**RFB-2024-65**  
**SUNY SCCC CST BUILDING LOBBY AND BATHROOM RENOVATIONS**  
**C2 DESIGN GROUP**

**ADDENDUM #1**

Issued Date: 12/5/2024

Sheet Number:  
**A104**

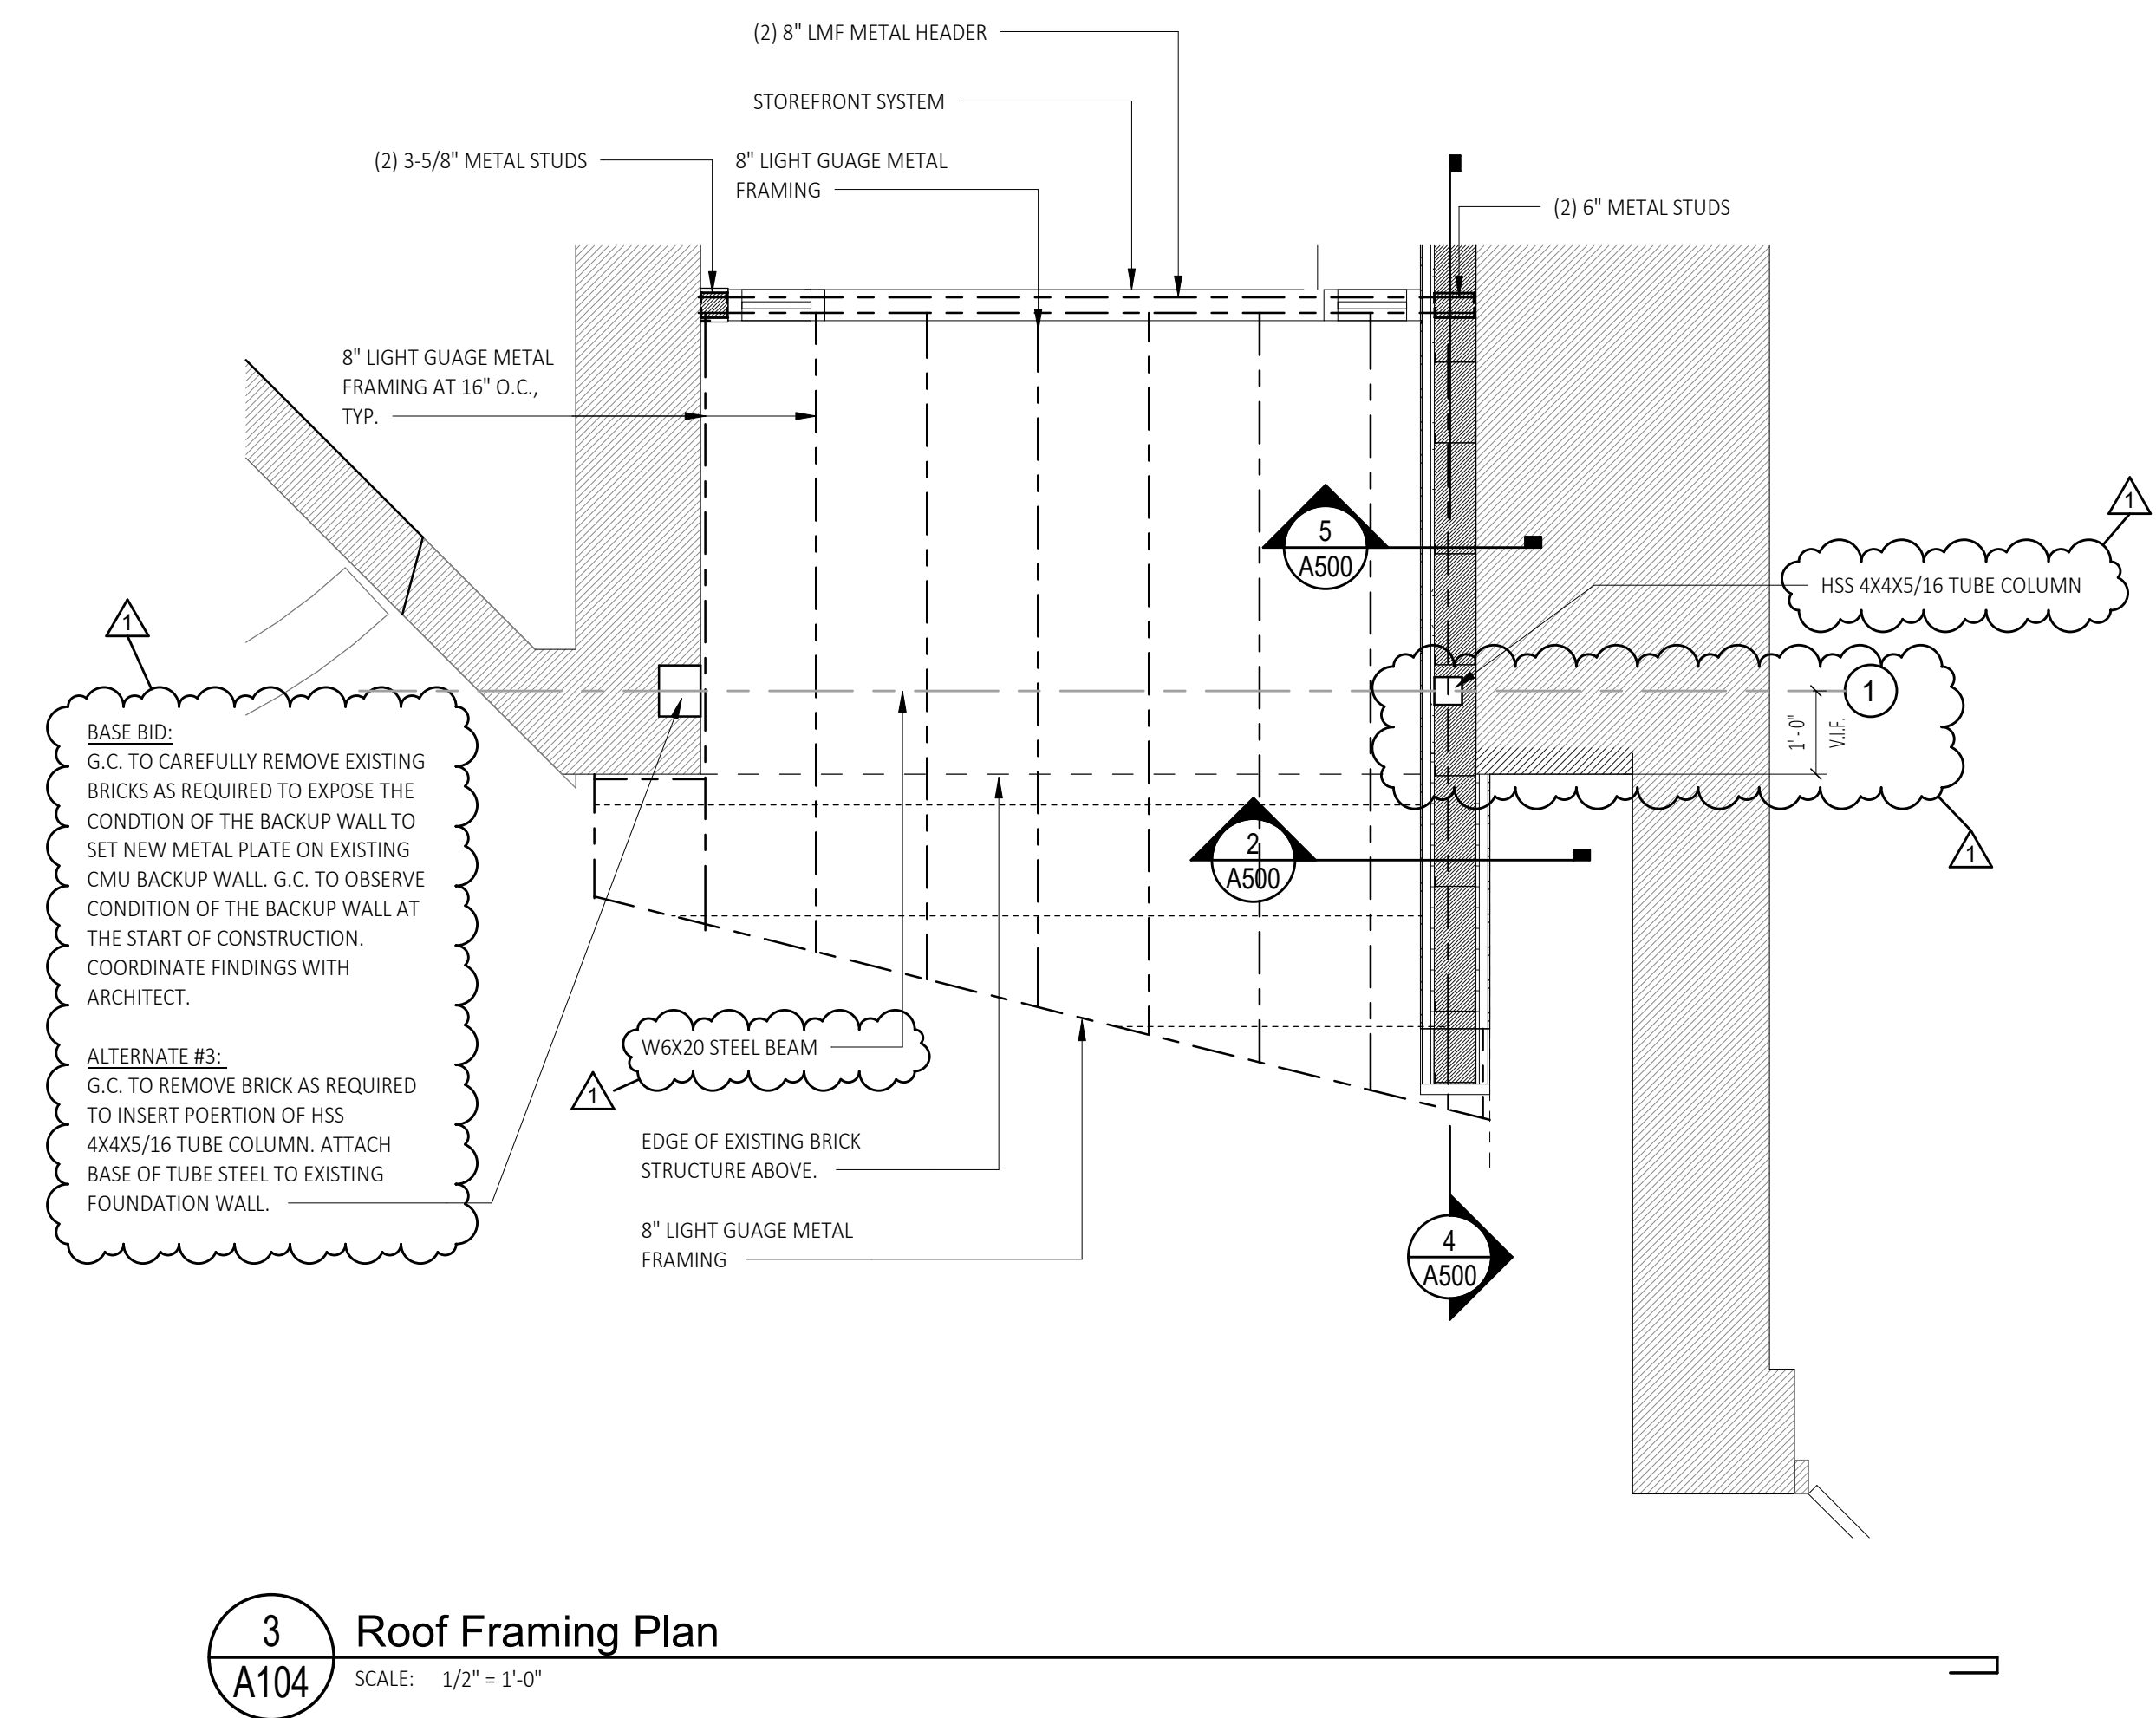
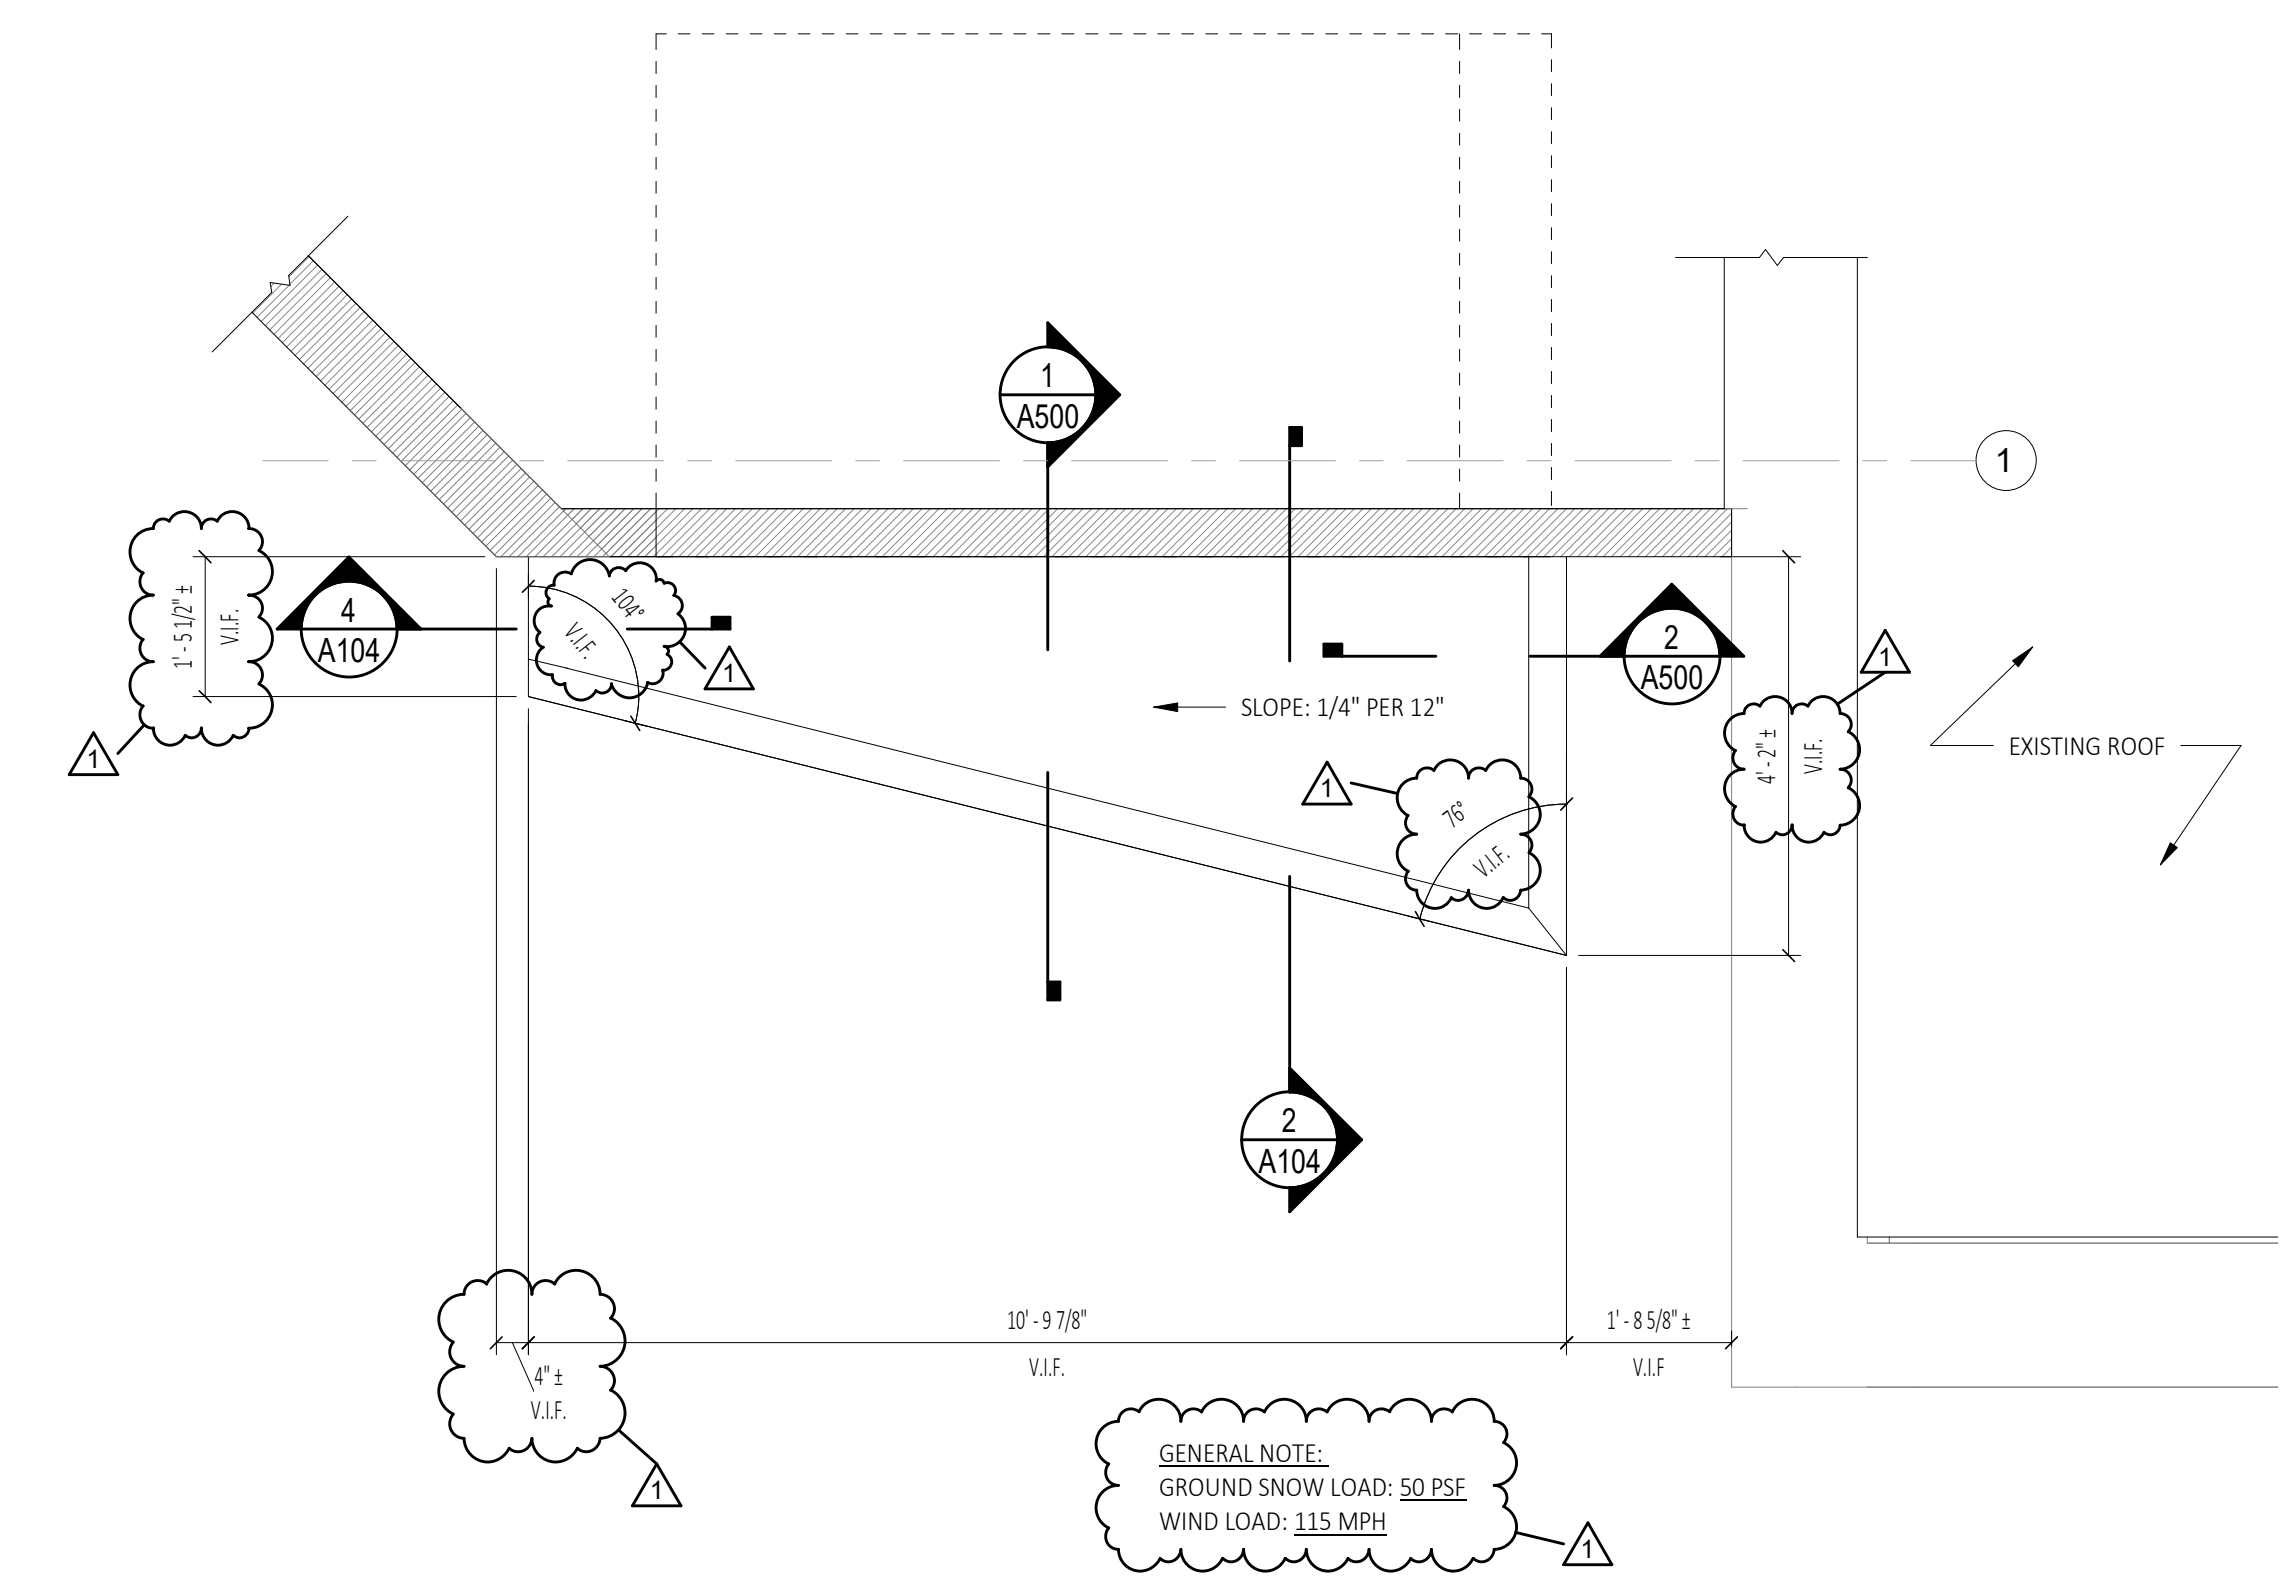
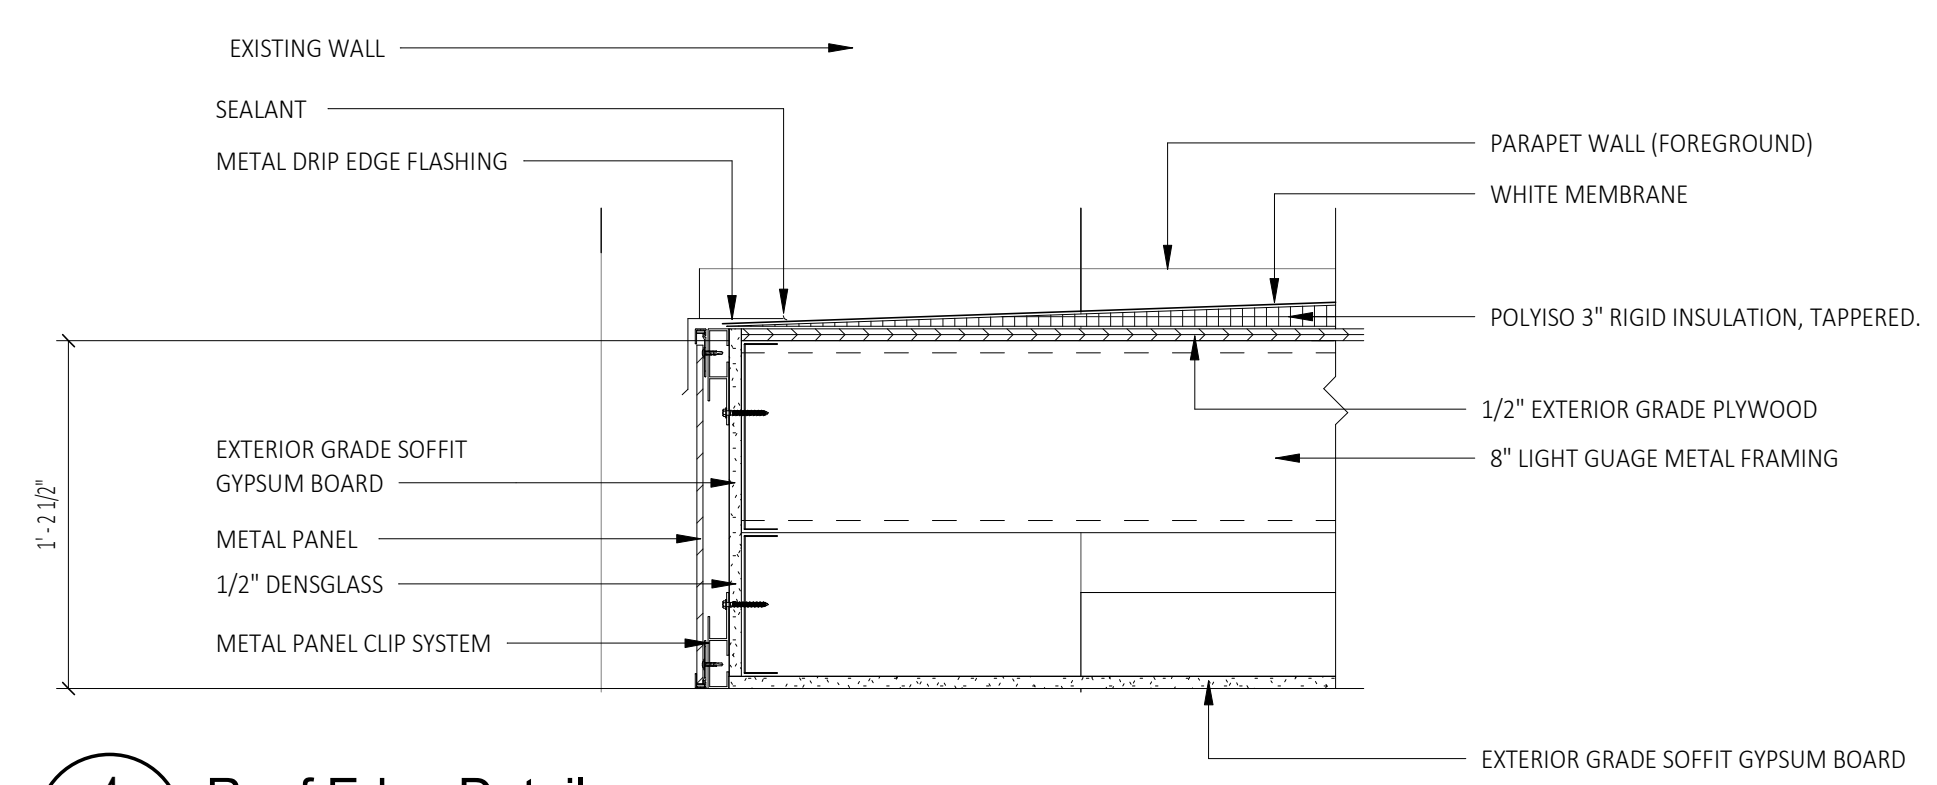
5. Drawing A104 – Roof Plan and Details
  - a. Revisions as marked Addendum #1
6. Drawing A200 – Building Elevations
  - a. Revisions as marked Addendum #1
7. Drawing A400 – Stair Sections
  - a. Revisions as marked Addendum #1
8. Drawing A500 – Exterior Details
  - a. Revisions as marked Addendum #1
9. Drawing A701 – Interior Elevations
  - a. Revisions as marked Addendum #1
10. Drawing A900 – Schedules
  - a. Revisions as marked Addendum #1
11. Specifications 08 41 13 – Aluminum Storefront Systems
12. Specifications 08 71 00 – Door Hardware
